THE MUNICIPALITY OF LAMBTON SHORES

Report COA 05-2025

RE: Consent Applications B-02/2025 to B-05/2025 and Minor Variance Applications A-02/2025 to A-05/2025 – Plan 10 Lot 42 N Pt Lot 43 - 65 MacNab Street, Forest – Mudassar Khan (Agent: Caden McAllister, Zelinka Priamo Ltd.)

ATTACHMENT 2: ORIGINAL SKETCH (APPLICANT)

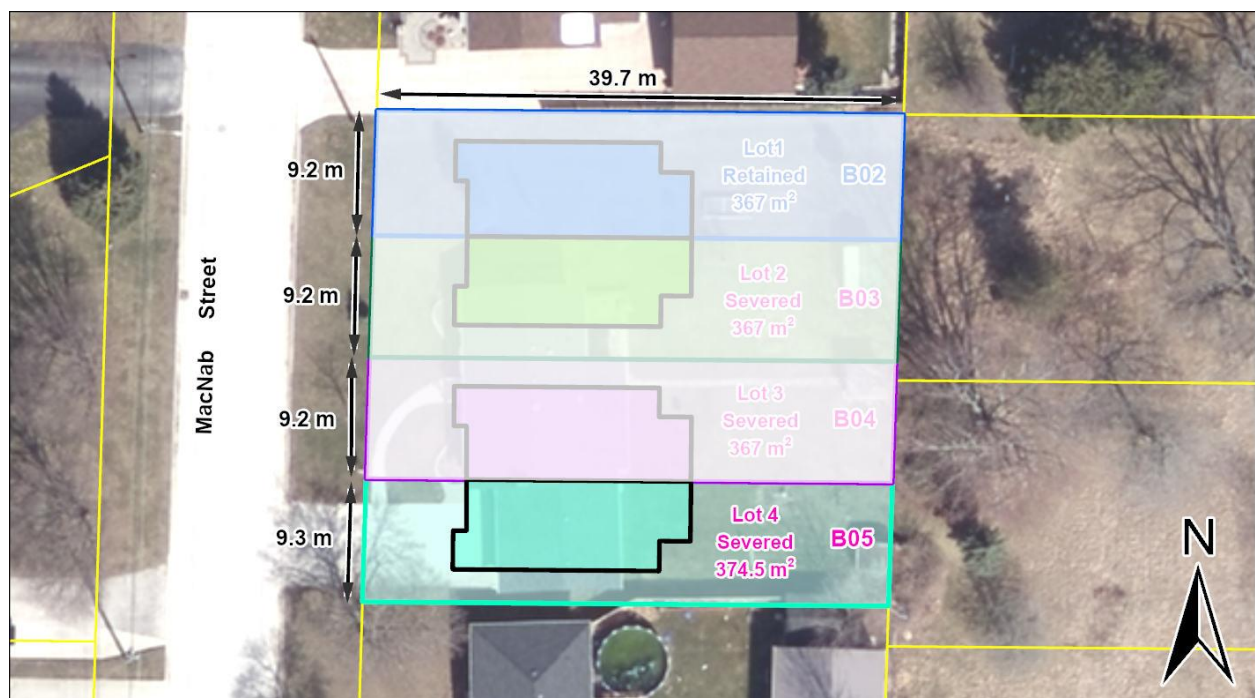
The applicant is proposing to remove the existing single detached dwelling and sever a total of four lots. Three lots (Lot 1, Lot 2 and Lot 3) would have a lot frontage of 9.2 m (30.18 ft) and a lot area of 367 m² (3,950.36 ft²) and one (Lot 4) would have a lot front of 9.3 m (30.51 ft) and a lot area of 374.5 m² (4,031.08 ft²). The applicant has indicated that the purpose of the severances are to construct four (4) two-storey semi-detached dwellings (one dwelling unit per lot) (see Attachments 2 & 3).

A closed municipal drain was identified through the detailed application review and public notification. It is located approximately 2.44 m (8 ft) from the north property line, running east to west and spanning the entirety of the north property line. Due to the presence of the drain a minimum setback of 5 m from the centre of the closed drain is required for any building or structure (see Attachment 3).

As a result, the location of the drain along with required setbacks (Drain and Interior Side Yard) render the northerly-most of the four proposed lots unbuildable.

The requested severances would create four (4) vacant residential lots (infill) within an established neighbourhood. However, due to the presence of a municipal drain only three (3) of the four (4) lots would be buildable due to the location of the drain and required setbacks. Planning Staff are therefore not supportive of the applicant's proposal for the creation of four (4) lots and in turn not supportive of the proposal for reduced lot frontages for the four (4) lots.

Discussion with the applicant's agent has resulted in the applicant providing a revised sketch for two (2) consents that result in the creation of three (3) vacant residential lots all meeting all site regulations for the R1 Zone including Lot Frontage which Planning Staff is supportive of (see Attachment 5).

Staff can support the revised concept noted above: the severance of the two (2) most southerly of the proposed lots (files B04-2025 and B05-2025) would be approved as lots for semi-detached dwellings, each lot with 10m frontages per the minimum requirement of the R1 Zone. This would leave a remnant parcel with 17.1m frontage as a building lot for a single detached dwelling.
